SUBJECT: Forwards "Final Summary Rept for DCRDR of Nine Mile Point Unit 1," per 841212 ltr & NRC 841226 reply. Rept represents completion of program commitments back to 830930 program plan. Rept includes results of NRC review/audit sessions.

Re: Nine Mile Point Unit 1  
Docket No. 50-220  
DPR-63

Subject: Final Summary Report for the  
Detailed Control Room Design Review  
of Nine Mile Point Unit 1

Figure E-1 Panel F Demarcation Line

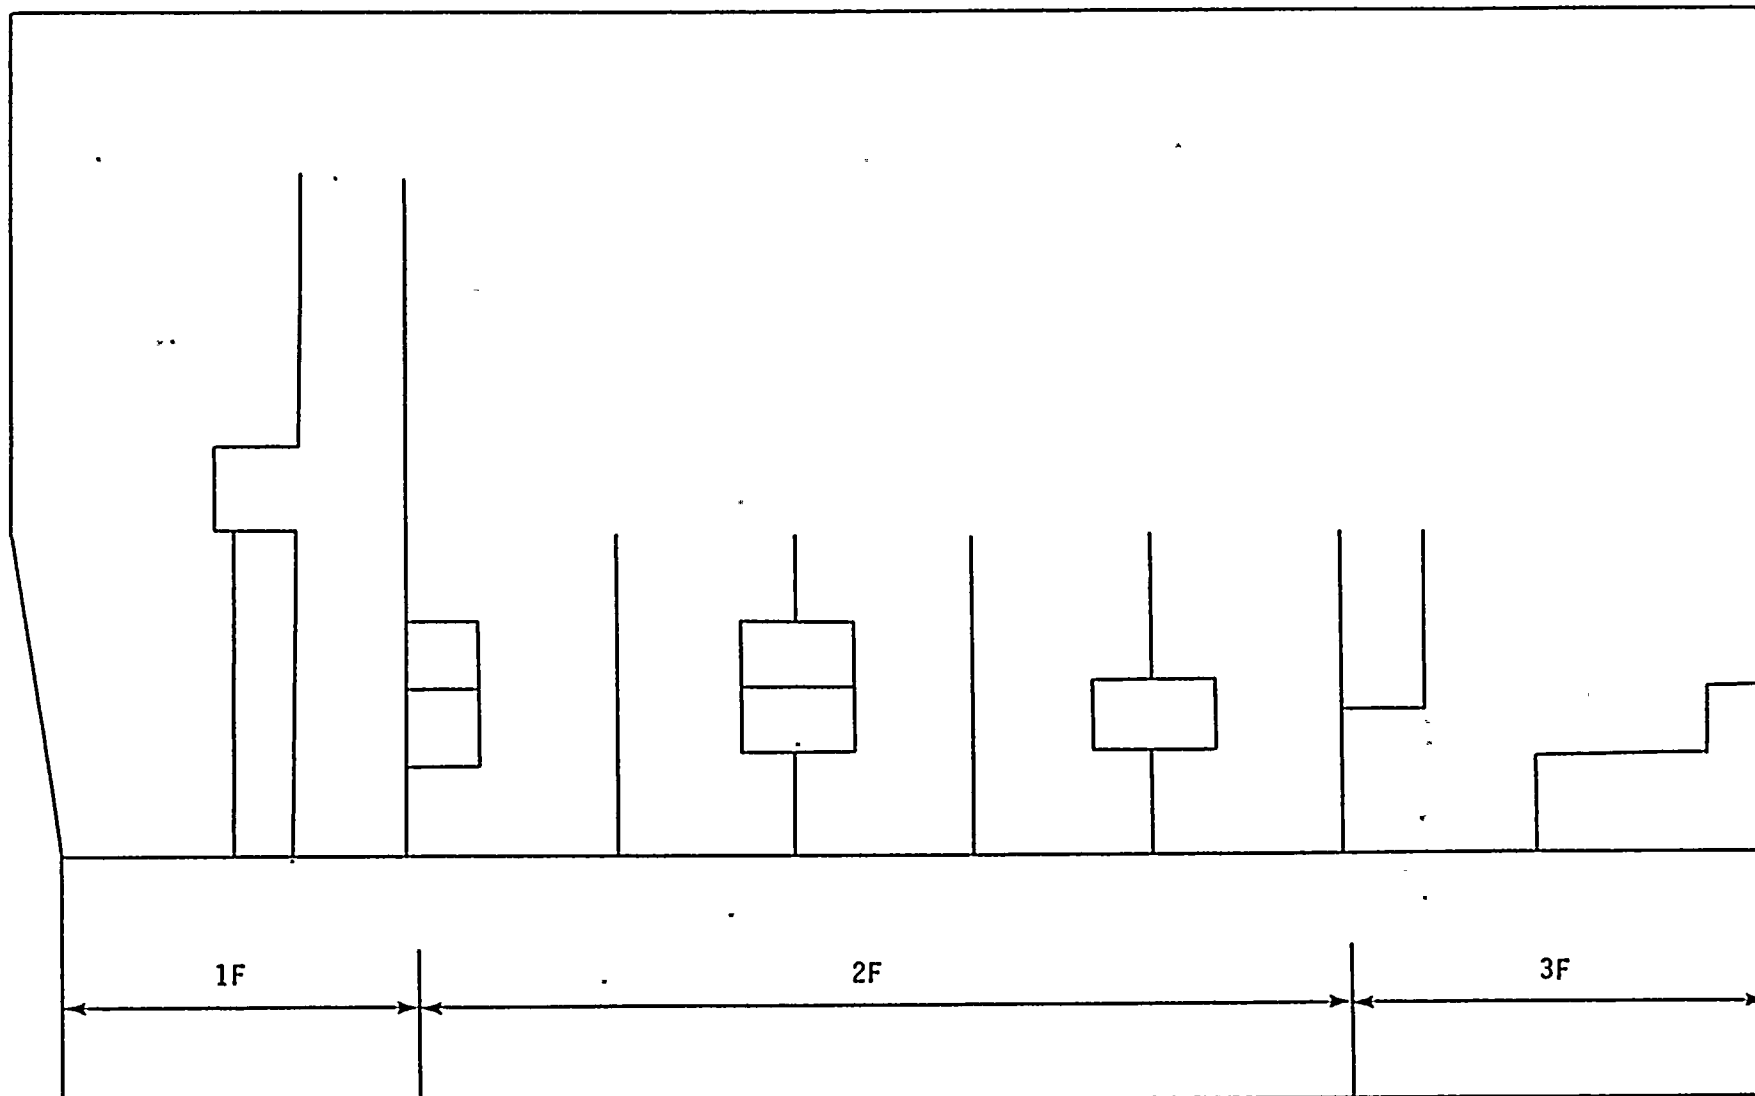
These are lines that were placed on the control panels to distinguish separate operational systems and subsystems. System and Subsystem labels were also added to aid this distinction and to reduce wording on component labeling with a hierarchial logic arrangement. Demarcation lines facilitate location of components because they break large control panels into smaller groups of functionally related components. Figures E-1 through E-4 show the placement of system demarcation lines.

Figure E-25 Panel L

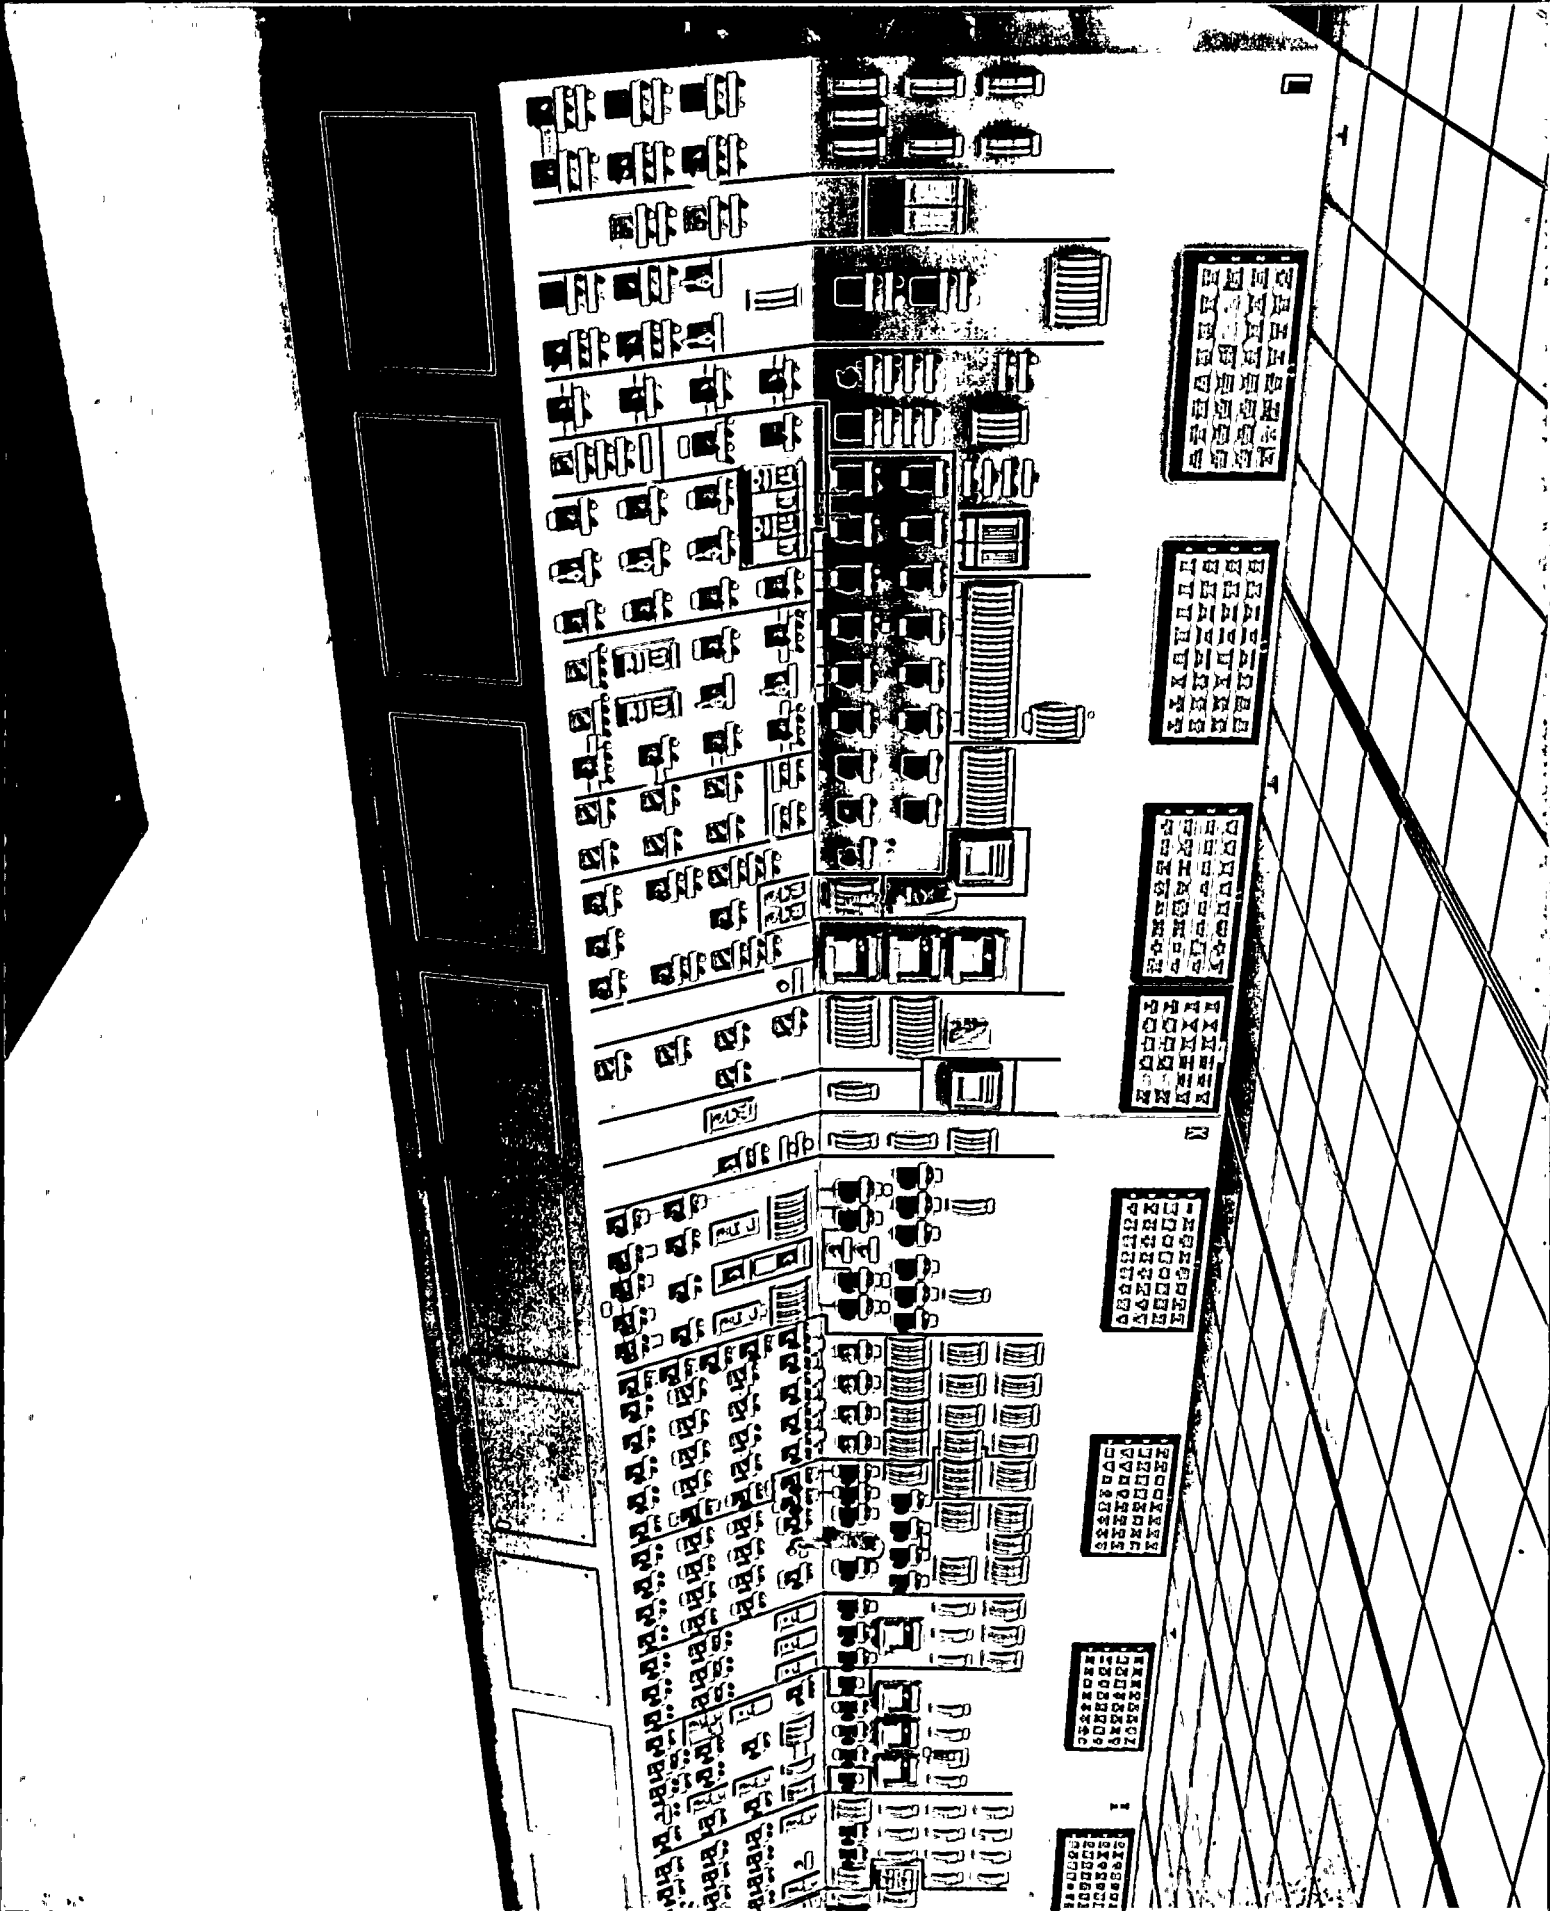
HEO resolutions illustrated by Figure E-25:

Figure E-23 Panel K and L

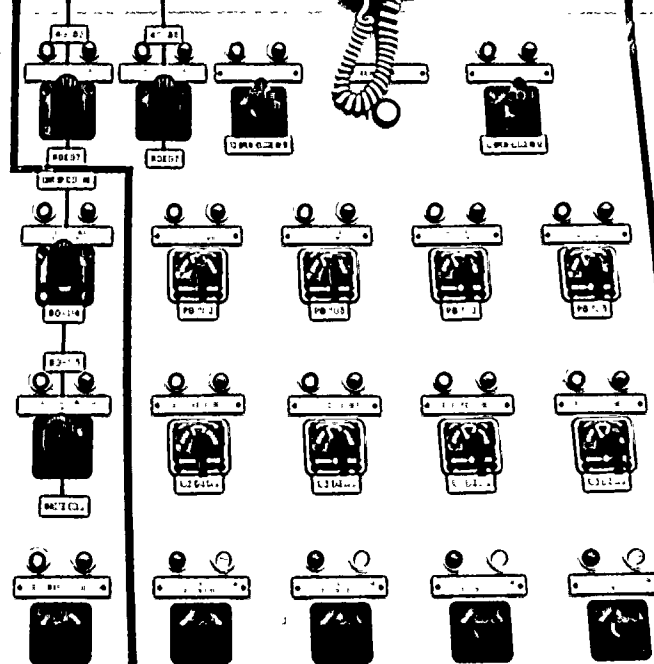
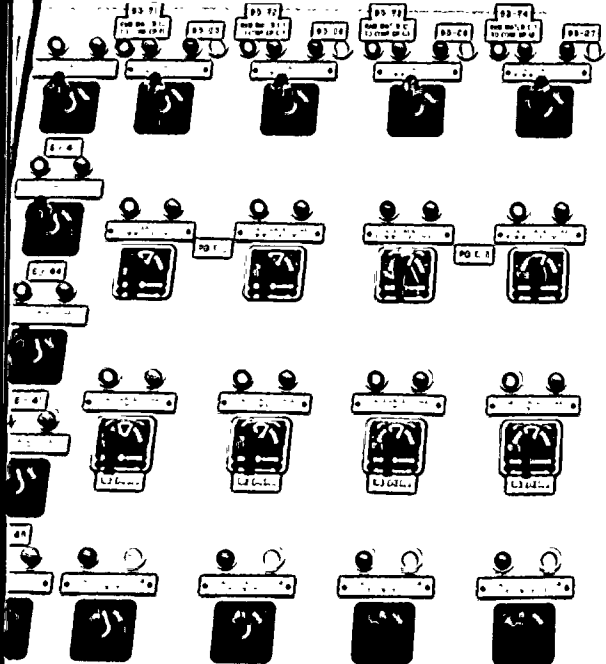
HEO resolutions illustrated by Figure E-23:
